May 2023 | Final Environmental Impact Report  
State Clearinghouse No. 2023010230

# **MCKINLEY ELEMENTARY SCHOOL CAMPUS MASTER PLAN PROJECT**

for Santa Monica-Malibu Unified School District

Figure 3-7c - Proposed Project Site Plan - Phase 3

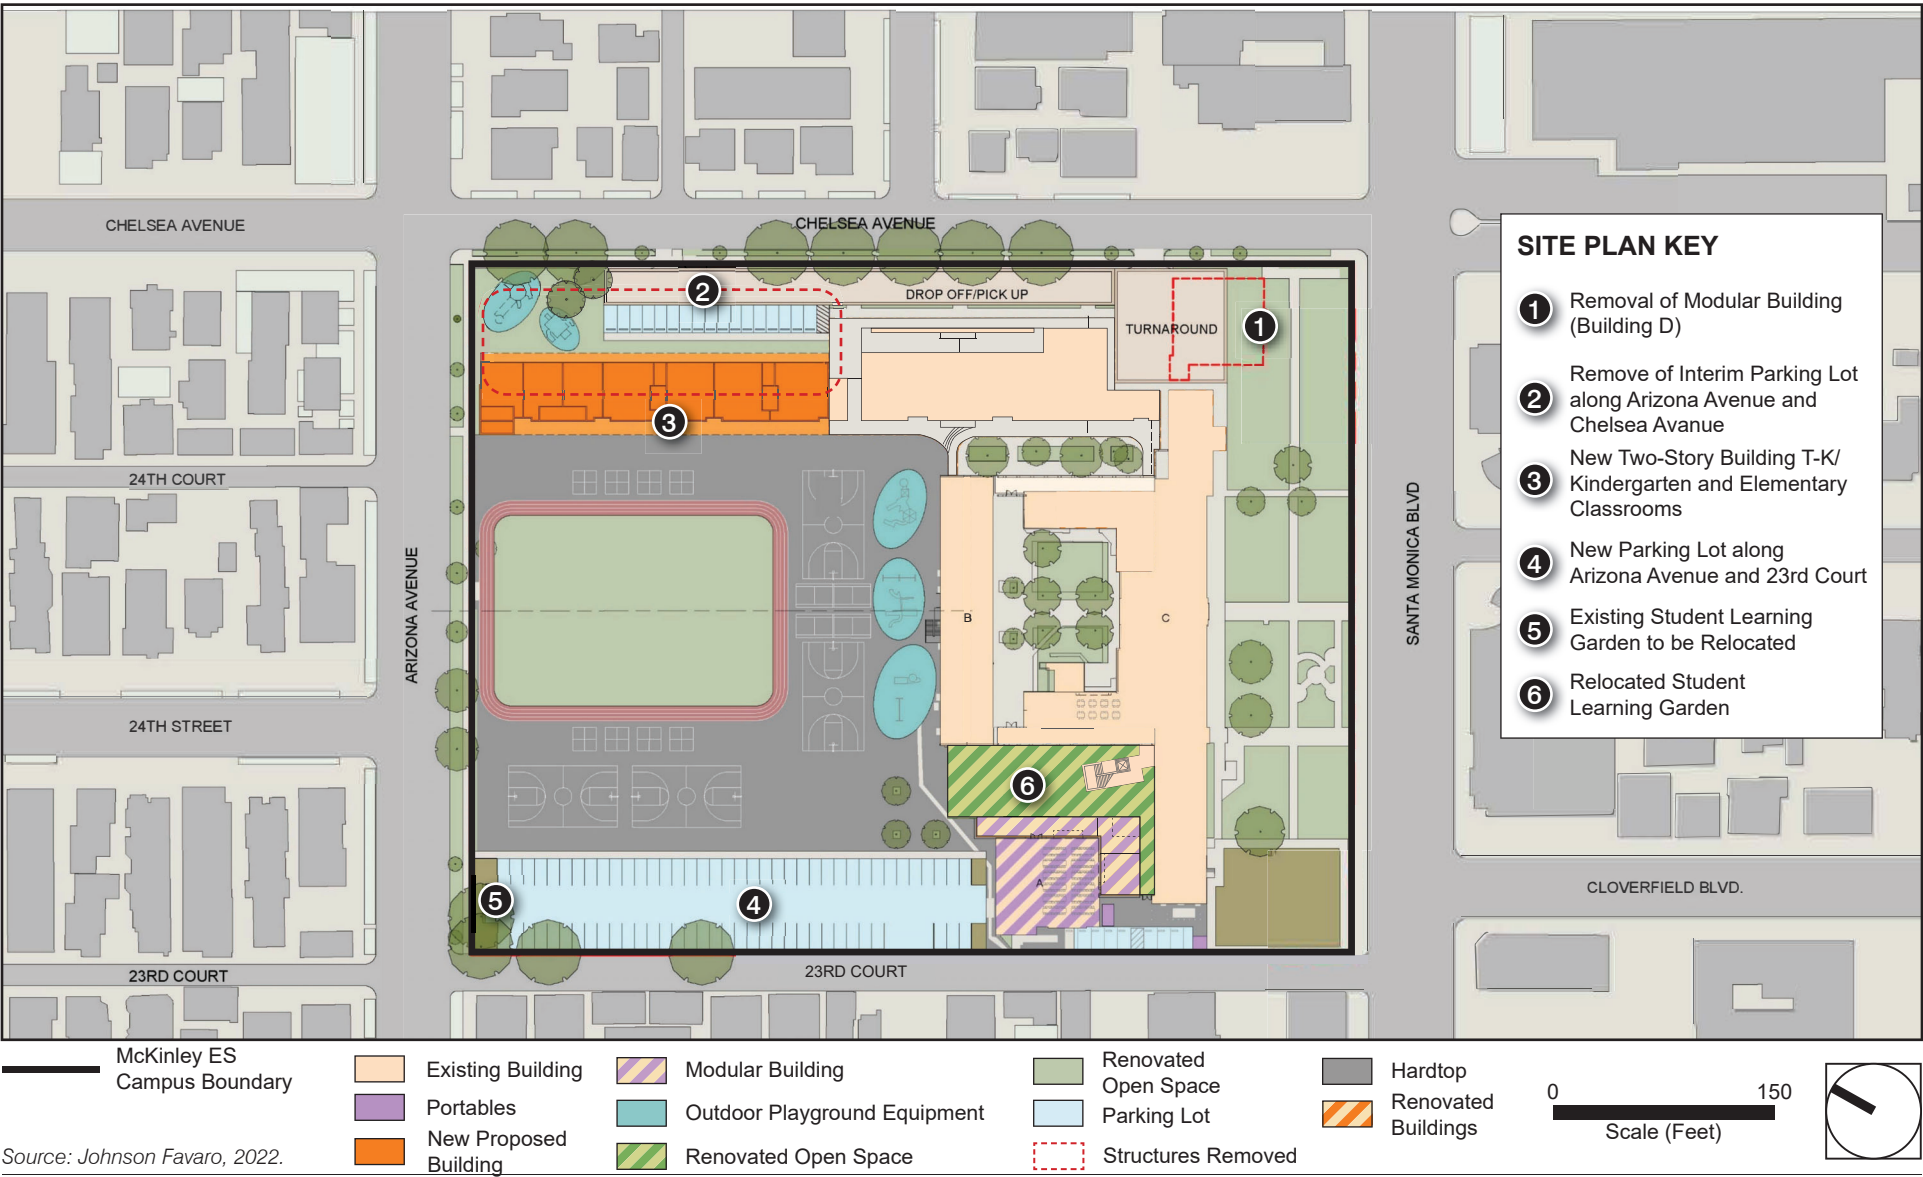
| <p>6. <b>Figure 3-7c Phase 3 (4)</b> references only "new parking lot along Arizona Avenue and 23rd Court." There is ZERO REFERENCE to the destruction of the decades old, mature, award-winning McKinley Student Learning Garden. There are NO PHOTOS in the entire plan of the existing Garden.</p>   | R5-10 |

- R5-10 This comment states that Figure 3-7c, *Proposed Project's Site Plan: Phase 3*, does not reference the location of the existing student learning garden.

In response to this comment, Figure 3-7c, *Proposed Project's Site Plan: Phase 3*, has been revised to identify the location of the existing student learning garden and location of the new student learning garden, adjacent to the cafeteria (Building A). The proposed figure revision does not require recirculation of the EIR because it does not provide significant new information that would give rise to a new significant environmental impact; a substantial increase in the severity of an environmental impact; or suggest a Project alternative or Mitigation.
